# Planning and Development (Technical Amendment—code, relocation and rezoning of FUA amendment) Plan Variation 2014 (No 1)

**Technical Amendment No 2013—16**

# Technical Amendment to the Territory Plan Variation 2013-16

Rezoning of land within the future urban area of Coombs, changes to the Coombs and Wright concept plan, relocation of provisions to Wright precinct code and other minor amendments

Figure 2

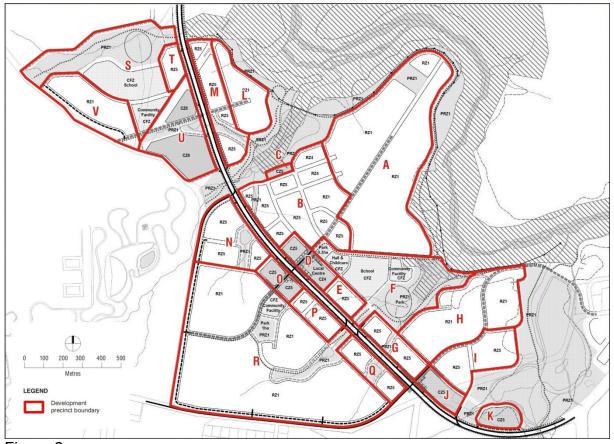
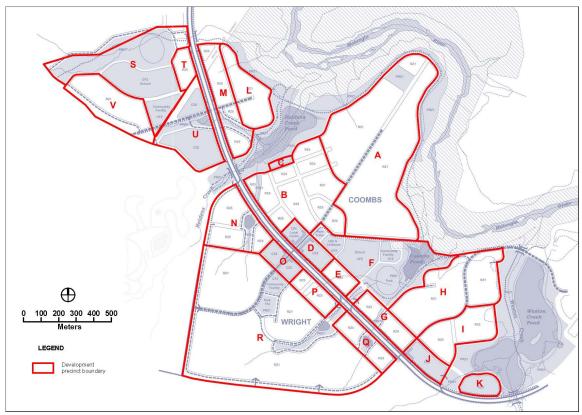
There are a number of planning and design advantages to be gained if the supermarket and attendant specialty retail is developed on the site zoned CZ5 rather than the original CZ4 site. To facilitate this, a swap of the zoning designations on the concept plan between the two sites has been made. This will provide for a significantly improved planning outcome as well as being in accord with the overall design intent for the centre.

Substitute with figures 2,3 and 4 at Appendix 2

Figure 2: Current Territory Plan map

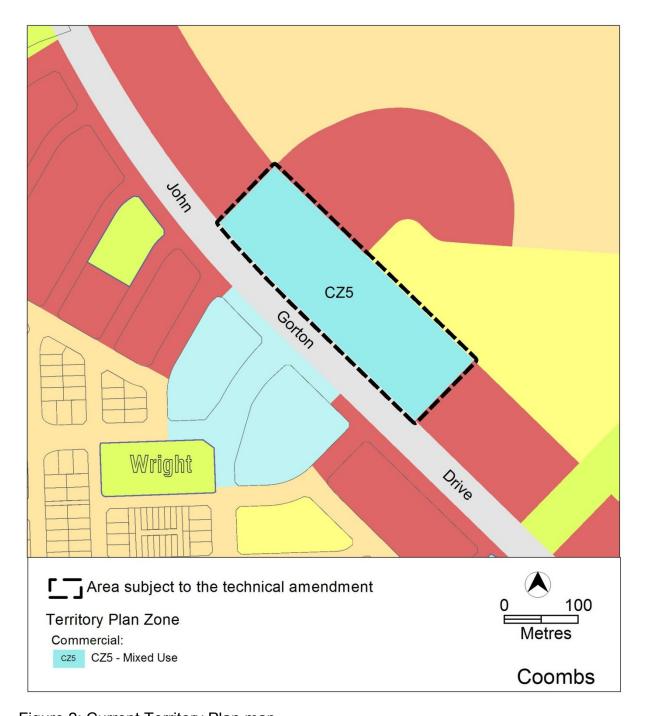
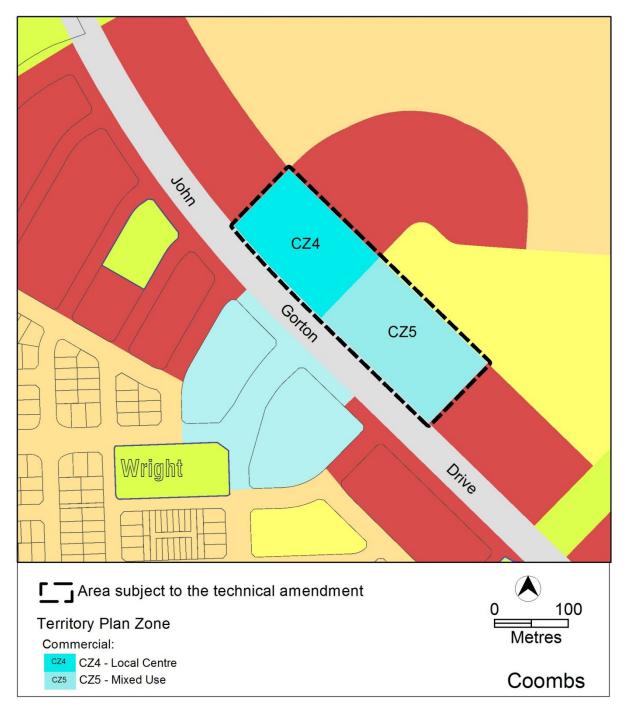
There are a number of planning and design advantages to be gained if the supermarket and attendant specialty retail is developed on the site that was zoned CZ5 rather than the CZ4 site. To facilitate this, a swap of the FUA zoning between the two sites has been undertaken via this technical amendment. This change provides for a significantly improved planning outcome as well as being in accord with the overall design intent for the centre. A statement of consistency against the Structure Plan for the proposed changes to the Territory Plan for Coombs Local Centre is at Appendix 1. The changes are considered to be consistent with the Structure Plan.

Substitute the 'Area subject to the technical amendment' in Figure 2 with the 'Area subject to the technical amendment' in Figure 3
